UNITED STATES PATENT AND TRADEMARK OFFICE

10/596,690

Office Action Summary	Application No. 10/596,690	Applicant(s) SIMON, YEHUDA YURI	
	Examiner David Laux	Art Unit 4193

DETAILED ACTION

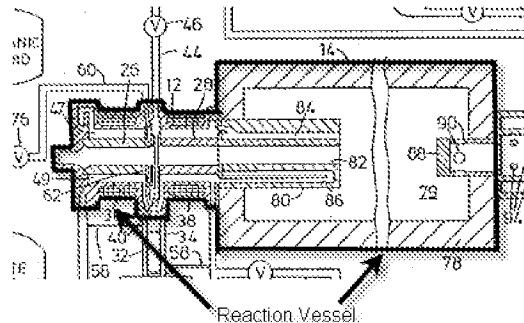
4. '877 discloses a system for neutralizing fluid chemical waste products, said system comprising: a pyrolysis/reaction chamber (See Fig. 1 reproduced in part below) having three or more openings (62, 40, 90) through which one or more plasma torches (26, 28) are inserted (40), through which one or more inlet conduits pass (62), and to which an exit conduit is connected (90); a pre-

pyrolysis subsystem comprising a container (64, 66) to collect said waste, a valve (68) to regulate the flow rate, and a pump (74), which pumps said waste from said container through said inlet conduits (60, 62); a post-pyrolysis subsystem (18); sensors that provide information concerning various operating parameters at different locations in said system (Col.5, line 58; Col. 11, lines 45-48); a control unit (Col. 8, lines 46-48; Col. 11, lines 45-48) ("Fully instrumented and monitoring equipped control room[s].." inherently are capable of acting as an input unit, storing information and performing computations.) that utilizes information provided by said sensors as well as other information provided to it from other sources in order to optimize and automate the operation of said system; and a display system (Col. 8, lines 46-48) ("Fully instrumented and monitoring equipped control room[s].." inherently are capable of having a display monitor) to provide the operator of said system with information concerning the operation and operating parameters of said system; an atomizer attached at the end pointing into said chamber of each of said inlet conduits through which said pump pumps said waste, thereby atomizing said liquid waste and creating a jet of small droplets (Col. 4, lines 18-20; '877 contemplates the use of an atomizer but does not require the use because the waste material is atomized as a result of being exposed to a plasma stream; atomizers are well known in the art and are one of a number of alternative spray methods that could be utilized in such a device); and each of said atomizers is located opposite the at least one plasma stream/s created by said plasma torch/es, wherein said location of said atomizers provides the conditions for effective contact of said droplets with said plasma stream/s
